**CITY OF LAKE WORTH,
AQUATICS AND BEACH COMPLEX**
Supplement to Property Condition Assessment

**RE: *Supplement to Aquatics and Beach Complex Baseline Property Condition Assessment
KH Job #140335001***

SUPPLEMENT TO PCA REPORT ISSUED ON MAY 9, 2017

EXHIBIT 4. VIEW OF CRACKED WATERLINE TILES AND CRACKED POOL BEAM

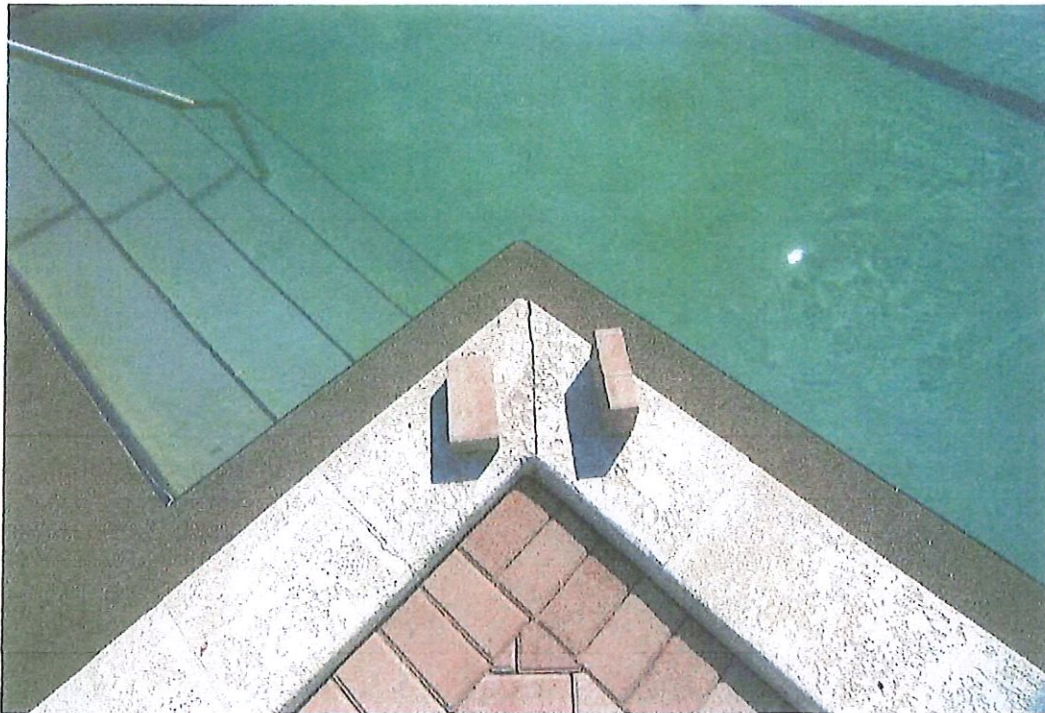
The observations noted in the SECO report were reviewed, evaluated, and compared to our field notes and findings summarized in the PCA. Of particular interest were SECO's observation numbers 6 and 7 referring to a "horizontal cracks in the pool beam". After reviewing that photos in exhibit 4 of SECO's report, the mentioned horizontal crack is actually the cold joint between the structural wall of the pool and the precast coping. The coping is adhered to the top of the wall, similar to a tile installation, so a joint occurs at that interface. This joint is located at or near the finished grade elevation of the surrounding pool deck pavers and is located above the waterline. This is not a structural joint and it is not meant to be watertight.

6. Examination of the pool beam in the Northwest corner of the pool, where a waterline tile was missing, revealed a horizontal crack in the pool beam.
7. Examination of the horizontal crack in the pool beam revealed that it appeared to be a cold joint between the previously existing concrete pool beam and a concrete overpour.

8. Continued examination of the horizontal crack in the pool beam revealed the presence of a caulking material along the crack, presumably installed to prohibit water seepage and/or prevent the crack from telegraphing into the waterline tile. It was noted that the caulking material did not extend along the entire length of the crack.

1. There is evidence of uneven settlement of the pool which may be the result of organic soils underlying the pool and deck. Soil testing in locations proximal to the settled section of the pool would be required to confirm this condition.
2. There are horizontal cracks in the pool beam at a cold joint from previous alterations.
3. The proper repair of the pool beam is as follows:
 - a. Remove the precast coping stones (reserve for re-use) and waterline tiles from the entire perimeter of the pool.
 - b. Remove the portion of the pool beam above the crack from the entire perimeter of the pool.
 - c. Acid-etch and neutralize the top of the pool beam.

EXHIBIT 8. VIEW OF HORIZONTAL CRACK IN WATERLINE TILES (REFERENCE EXHIBIT 6.)

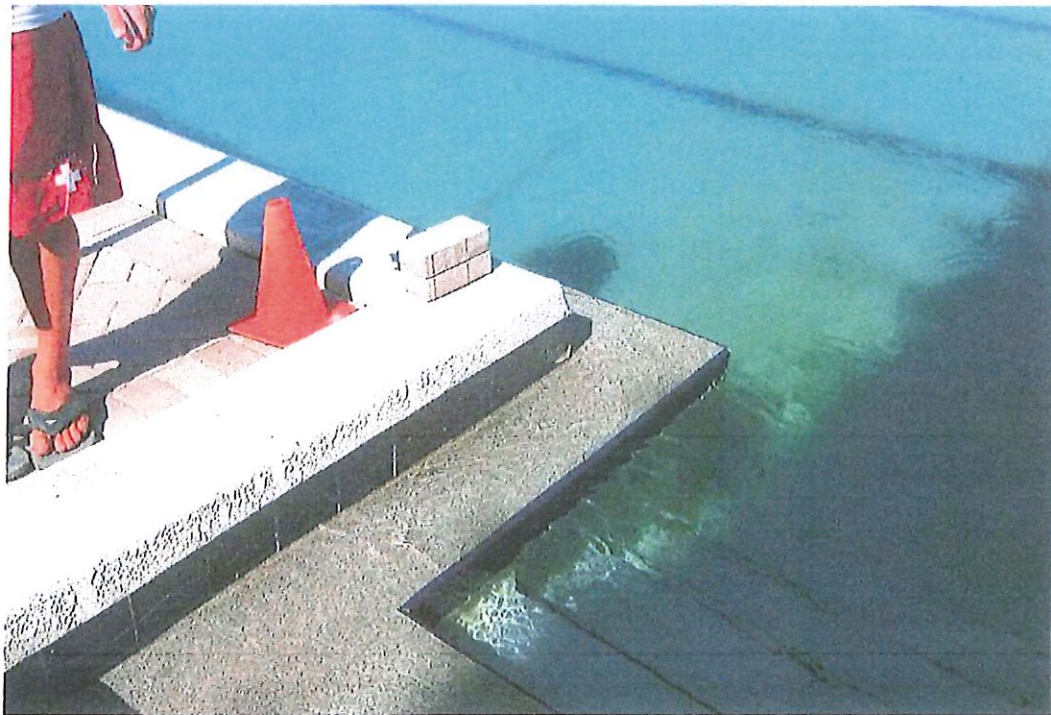
5. Examination of the waterline tiles revealed a horizontal crack at approximately the mid-height of the waterline tiles at the back of the gutter. This condition was noted in several areas.
